Determination 2020/032

Regarding the compliance of a soil fixture space without a hand basin with Building Code Clause G1 Personal hygiene at 38 Sandhurst Drive, Rolleston, Christchurch

This determination considers the compliance of a soil fixture space which does not contain a hand basin. The determination discusses the term “immediately adjacent” and whether the soil fixture space without a hand basin complies with Building Code Clause G1 Personal hygiene by way of the Acceptable Solution G1/AS1 and if not whether the space complies with Clause G1 as an alternative solution.

Figure 1: Floor plan (Not to scale)

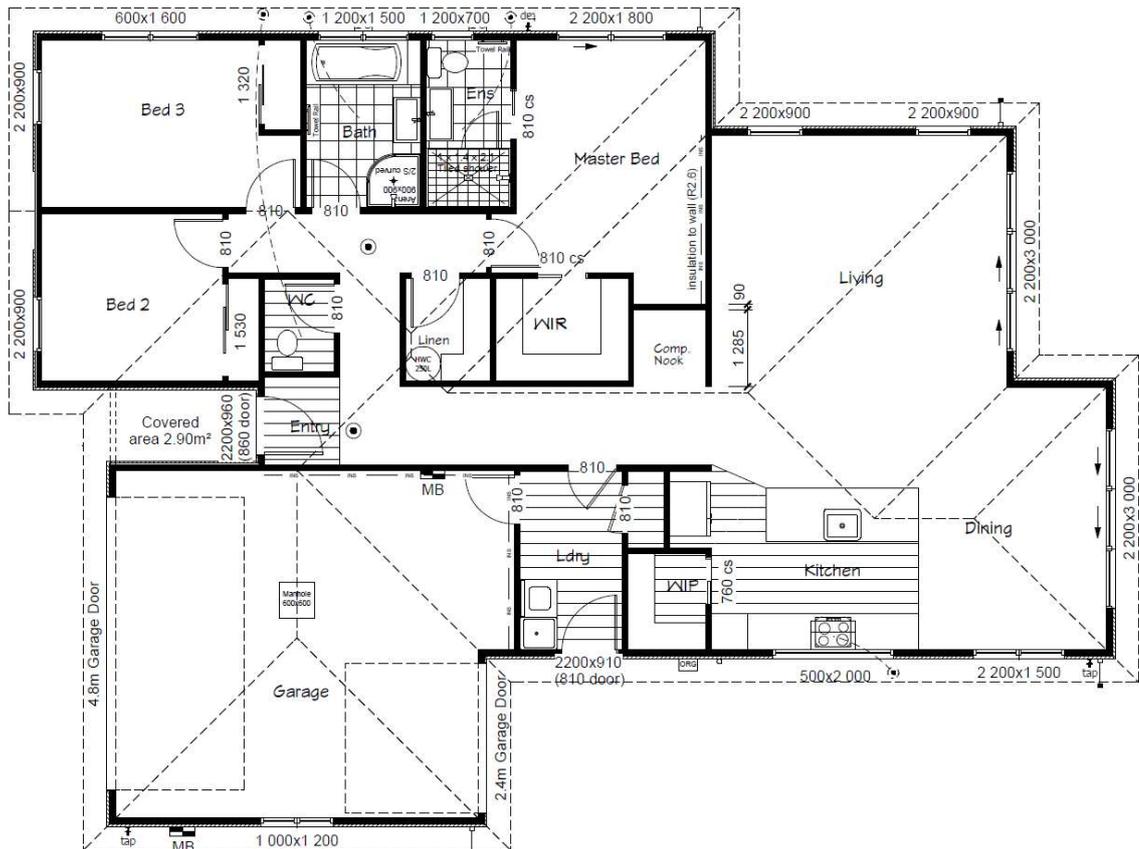
- 2.1 As shown in Figure 1, the single storey 3 bedroom residential dwelling includes a double garage, a separate laundry, and an open plan living/dining and kitchen area. A hallway provides access from the entry to the bedrooms, bathroom, the WC and linen closet and to the open plan living and kitchen area.

4.8 I agree with the authority that there are two parts to paragraph 3.3.1 of G1/AS1 that need to be considered. Addressing the second part to paragraph 3.3.1 of G1/AS1 first; there is only a single door provided between the WC and the kitchen and as there is no basin in the WC the requirements of paragraph 3.3.1 of G1/AS1 have not been met.

- 4.11 In considering the Oxford English Dictionary definitions of “immediately” and “adjacent” (refer paragraph 3.5) I am of the view that an “immediately adjacent” space in the context of paragraph 3.3.1 of G1/AS1 could mean a space that is:
- adjoined to the space, or
 - next to the space without any intervening space.
- 4.12 The Oxford English Dictionary definition of *adjoin*⁸ means “Be next to and joined with (a building, room, or piece of land)”. As the bathroom is not adjoined to the WC, I am of the view that it is not an “immediately adjacent” space for the purposes of G1/AS1 paragraph 3.3.1.
- 4.13 The bathroom is close enough to the WC to be considered next to it, however there is an intervening space between the WC and the bathroom being the hallway, therefore the bathroom cannot be considered immediately adjacent to the WC for the purposes of G1/AS1 paragraph 3.3.1.

- 4.19 While I note there is “intervening space” between the WC and the bathroom, in this instance I agree with the agent that walking out of the WC (either with the door as located in Figure 1 or opposite the bathroom as shown in Figure 2) to the bathroom is not substantially different to walking out of the WC and into an adjoined bathroom,

- 4.23 As shown in Figure 1 the bathroom is located relatively near to the WC compared to the location of the kitchen. Given this, and that the laundry which contains a tub is also located between the WC and the kitchen, I am of the view that the essential requirement to have a basin immediately available to users of the WC before handling food has been met. Therefore I am satisfied the sanitary fixtures are located to facilitate sanitation and avoid risk of food contamination, and the design complies with performance criteria G1.3.2 as an alternative solution.

- 5.1 In accordance with section 188 of the Building Act 2004, I hereby determine that:
- The WC without a basin does not satisfy paragraph 3.3.1 of G1/AS1.
 - The WC without a basin complies with Clause G1 Personal hygiene as an alternative solution.

Figure 2: Alternative location of WC door (Not to scale)

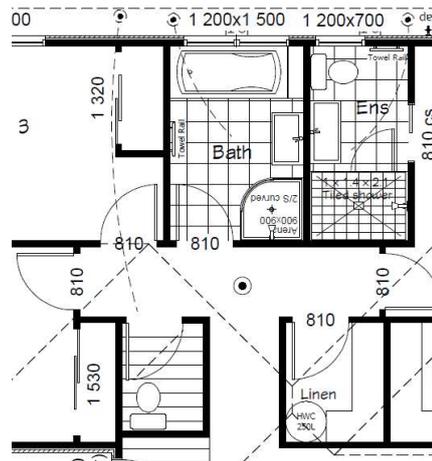
- 2.5 The authority advised that with or without the additional door, the design remained non-compliant due to the WC not being immediately adjacent to the bathroom which contains a basin.
- 2.6 On 21 February 2020 the agent provided to the authority a revised design showing a basin in the WC and advised the authority of their intent to seek a determination.
- 2.7 The building consent was issued on 24 February 2020 and the Ministry received an application for determination on the same day, which was accepted on 9 March 2020.

- 3.2 In their covering letter the owners advised they are seeking clarification on paragraph 3.3.1 of G1/AS1 asking if relocating the WC door to be opposite the bathroom or adding a second door between the WC and the kitchen would comply with paragraph 3.3.1 of G1/AS1.
